Project: Austin Light Rail Phase I
To: File
Cc:
From: ATP
Subject: North Shore Design Changes
Date: June 30, 2025

2. Changes to the North Shore Design

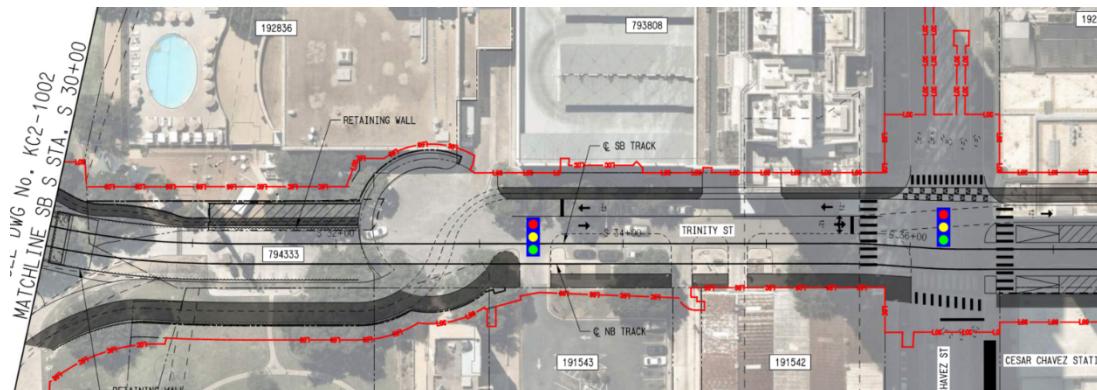
The original design for the North Shore segment featured a center-running guideway along Trinity Street, with travel lanes on either side of the light rail and pedestrian and bike connections crossing the tracks to reach the Ann and Roy Butler Hike and Bike Trail. While functional, this layout presented challenges for large vehicle access, limited flexibility for utility coordination, and constrained multimodal circulation.

In the updated design, the guideway has been shifted to a side-running configuration on the east side of Trinity Street. This adjustment consolidates both travel lanes to the west, improving access to existing loading docks, the Austin Energy transmission easement, and the Waller Creek Tunnel outlet, which occasionally requires large vehicle entry.

The revision also enables a nearly continuous 8-foot-wide path along the west side of Trinity Street, providing a more direct and intuitive connection to the Ann and Roy Butler Hike and Bike Trail. Coordination with Austin Energy poles, an existing electrical vault, and a proposed electrical manhole is ongoing to maintain path continuity and reduce conflicts.

An additional benefit of consolidating both travel lanes to the west of the guideway is a reduced lane shift for northbound Trinity Street when crossing East Cesar Chavez Street.
